Project	IEEE 802.16 Broadband Wireless Access Working Group < http://ieee802.org/16 >	
Title	Clarification on the UL ACK Channel	
Date Submitted	2005-01-24	
Source(s)	Myung-Kwang Byun, Seungjoo Maeng, Jaeho Jeon, Soonyoung Yoon, Panyuh Joo	mk.byun@samsung.com
	<p>Samsung Electronics Co., Ltd. Dong Suwon P.O.Box 105 416, Maetan-3dong, Yeongtong-gu, Suwon-city, Gyeonggi-do, Korea 442-600</p>	
Re:		
Abstract	Clarification on the UL ACK Channel	
Purpose	Adopting of proposed method into P802.16e	
Notice	This document has been prepared to assist IEEE 802.16. It is offered as a basis for discussion and is not binding on the contributing individual(s) or organization(s). The material in this document is subject to change in form and content after further study. The contributor(s) reserve(s) the right to add, amend or withdraw material contained herein.	
Release	The contributor grants a free, irrevocable license to the IEEE to incorporate material contained in this contribution, and any modifications thereof, in the creation of an IEEE Standards publication; to copyright in the IEEE's name any IEEE Standards publication even though it may include portions of this contribution; and at the IE

Figure bb1—Subcarrier mapping of UL ACK modulation symbols for PUSC

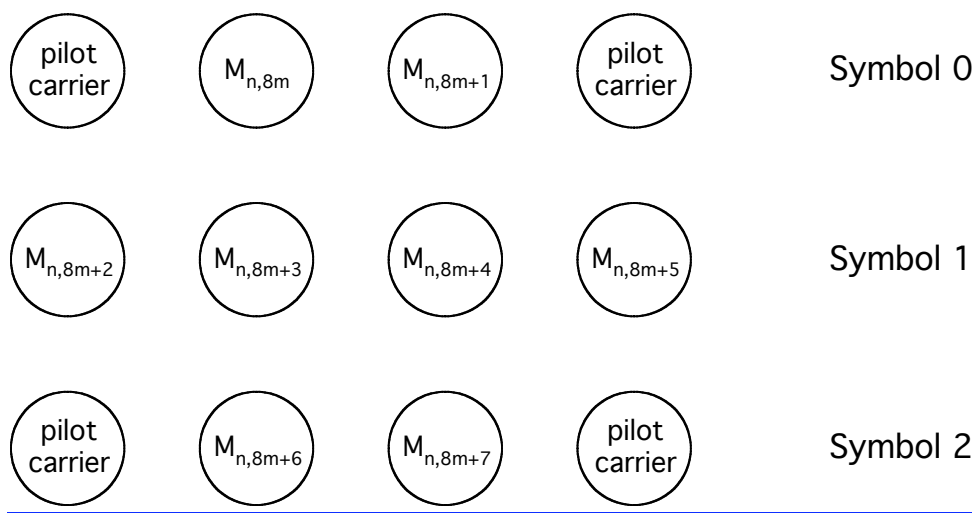
$M_{n,8m+k}$ is mapped to UL ACK channel tile as shown in Figure bb1 for PUSC uplink subchannel and in Figure bb2 for optional PUSC uplink subchannel. An UL ACK channel is mapped to half subchannel composed of 3 tiles.
